INVITATION TO TENDER NO. PS20200336
CONTRACTOR FOR RAYCAM COMMUNITY CENTRE PLAYGROUND REPLACEMENT

QUESTIONS AND ANSWERS NO. 1

ISSUED ON JUNE 15, 2020

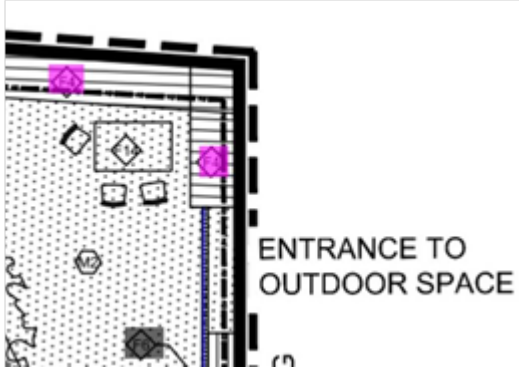
Q11	What will be the primary site-access? Will we be able to close off the Laneway to the south of the property for staging materials and equipment?
A11	<p>Laneway access cannot be closed off for staging materials and equipment.</p>  <p>The diagram is a site plan showing a building footprint at the top left. A dashed line indicates a boundary or path. Two pink diamond markers are placed on this path. Below the building, there is a large area with a stippled pattern, labeled 'ENTRANCE TO OUTDOOR SPACE'. A blue line runs vertically along the right side of this area, possibly representing a laneway or a specific access point. Various symbols like squares and circles are scattered within the stippled area, likely representing playground equipment or other site features.</p>
